PLANNING DEPARTMENT
Staff Report & Recommendation

Design Review Board

DATE: June 4, 2024

SUBJECT: DRB24-1014
4-6 Star Island

7. A variance from Sec. 7.2.2.3.b.12.B. to exceed by 5'-9" the maximum height allowed of 12'-0" in order to construct a one-story accessory structure up to 17'-9" high.

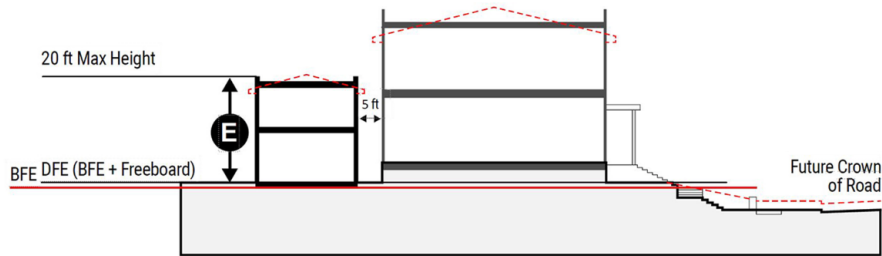
The Applicant is requesting a five (5) foot height variance for the one-story cabana accessory structure at the rear yard. The cabana is proposed at a height of 17 feet and 9” which exceeds the maximum height of 12’ for a one-story accessory structure. It is important to note that for accessory structures, the height is measured from base flood elevation plus one foot of freeboard. When facing a waterway, the minimum setback for a one-story accessory structure is one half of the required rear setback. In contrast, the minimum required setback for a two-story accessory structure along an interior side yard is 10 feet or the required side yard setback. The rear setback for a two-story accessory structure consists of one half of the required rear setback or 15’, whichever is greater.

Staff is supportive of the height variance due to the proposed accessory structure complying with the greater setback requirements of a two-story structure. The lush landscaping along the side yard is set partially on a lower terrace than the pool and therefore minimizing the height in relation to the pool. Consequently, the granting of the variance requested will not confer on the applicant any special privilege that is denied by these land development regulations to other lands, buildings, or structures in the same zoning district. While staff has no objection to the granting of the proposed variance, pursuant to Article I, Section 2 of the Related Special Acts, the maximum height variance that can be approved by the board is three (3) feet. As such, staff recommends that the variance be approved, not to exceed 3 feet.
